MEMORANDUM

Date: May 6, 2020	
To: Gian Martire, Senior Planner	Organization: City of Cupertino
From: RRM Design Group	Title: Architectural Review Team
Project Name: Cupertino Consulting Architectural Review Services	Project Number: 1832-00-UR19 (20-01)
Topic: Westport Density Bonus Waiver Review – Enhanced Senior and Family Living Project

Proposed Project - Site Plan

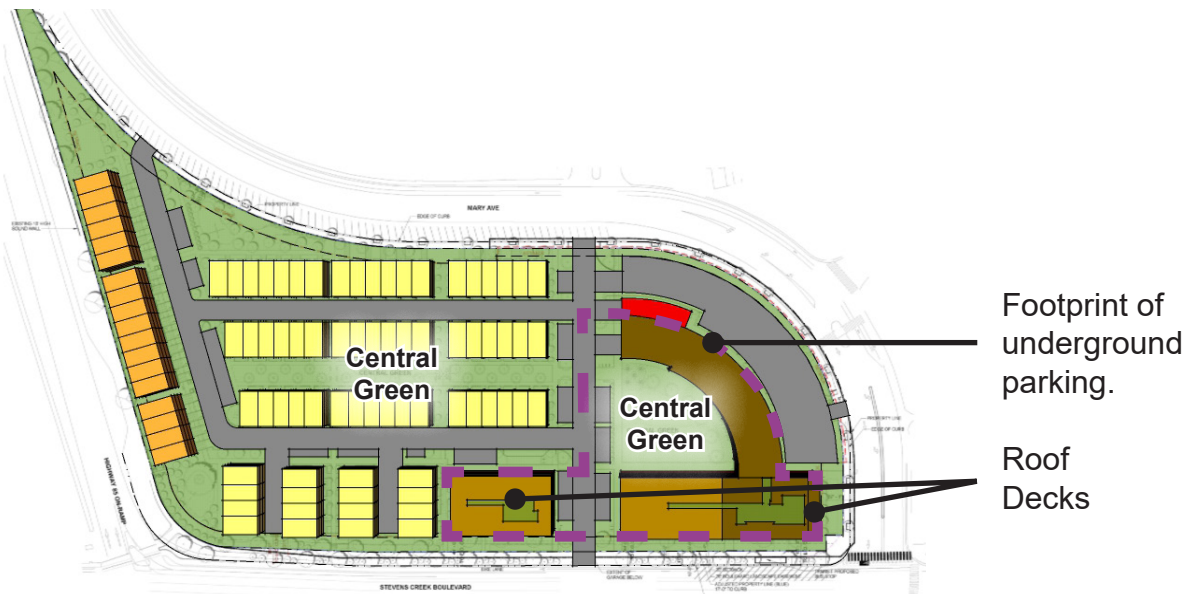
In order to provide a baseline understanding of the currently proposed project, Site Setbacks Sheet G203 was brought into Sketchup, a 3D modeling program, at scale (1 inch = 40 feet) as indicated on the plan sheet. This to-scale site plan provided the foundation for recreating the proposed project in 3D in order to allow for the more in-depth analysis requested by the City as part of this review effort. Other relevant project information, such as property boundary locations, setback locations, floor-to-floor heights, was also captured in the model to inform the analysis portion of this effort as shown below. It should also be mentioned that the slope line setback standard was also modeled at the 45-degree angle from curbline to allow for a clear understanding of how this standard would or would not affect the project design.

Proposed Project without Height or Slope Setback Line Waivers - Site Plan

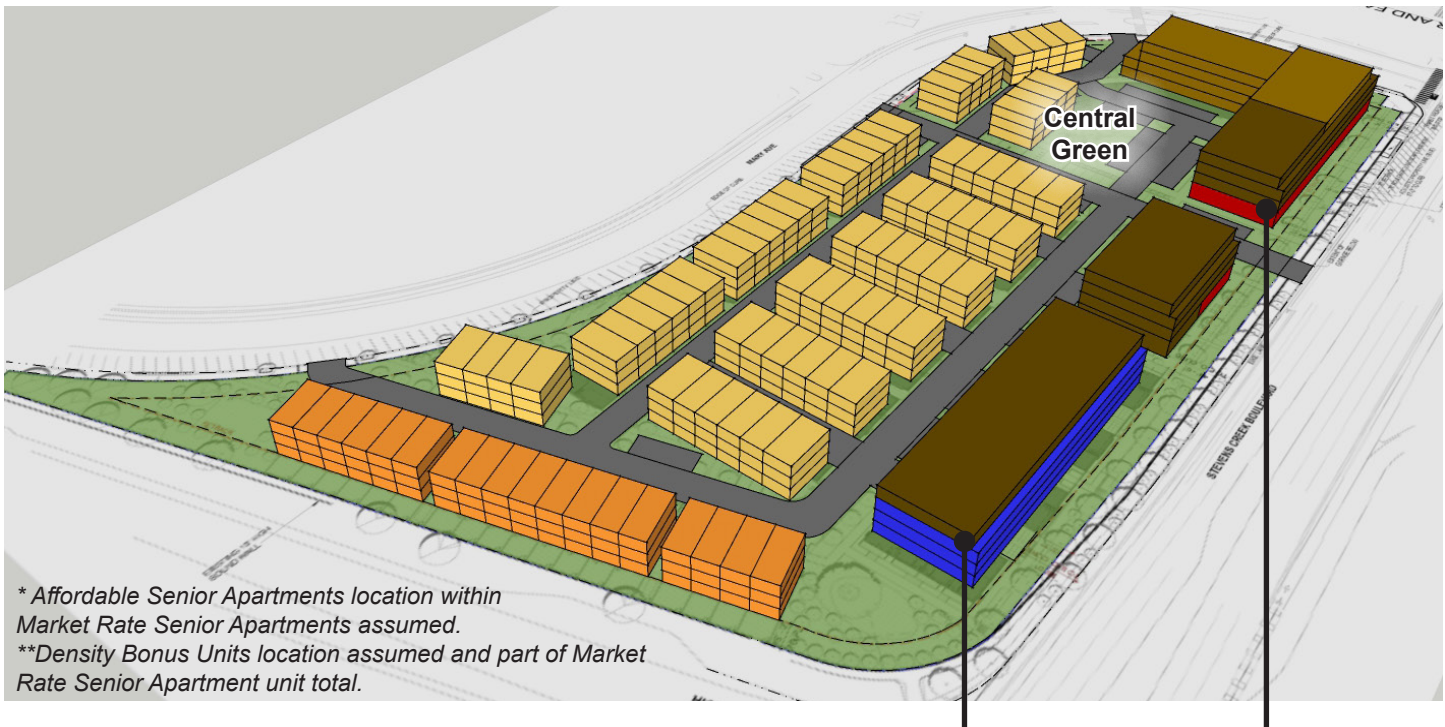
Under the Proposed Project without Height or Slope Setback Line Waivers, both the height and slope setback line waivers were removed from the project. This limited the building heights to 45-feet and included the 45-degree slope setback from curblane requirement, as required by the HOCSP.

As seen in the graphic below, removal of both waivers necessitated the relocation of a significant portion of the Market Rate Senior Apartments from Building 1 to be located along Stevens Creek Boulevard and portion of Mary Avenue to accommodate the slope line setback requirement. In general, additional site area required to accommodate the expanded building footprint area, surface parking, and internal roadway layout reduced the total square footage of common residential and common landscape open space areas at ground level, as required under HOCSP 1.01.040.C.2.A. Moreover, while retail square footage was able to be maintained, retail support space identified as loading, trash, and lobby space, was not able to be accommodated.

Market Rate Senior units at 4th story reduced in size to accommodate slope setback.

Retail floor-to-floor height reduced to 15-feet.

- Decrease in total size of Market Rate Senior Apartment units at top floor due to slope line setback requirement along Stevens Creek Boulevard and portion of Mary Avenue.
- Loss of required common residential and common landscape open space areas at ground level to accommodate reconfiguration of building footprint area, surface parking, and internal roadway layout.
- Maintain retail square footage but reduction in retail support space.
- Retail floor-to-floor plate height reduced from 20-feet to 15-feet.
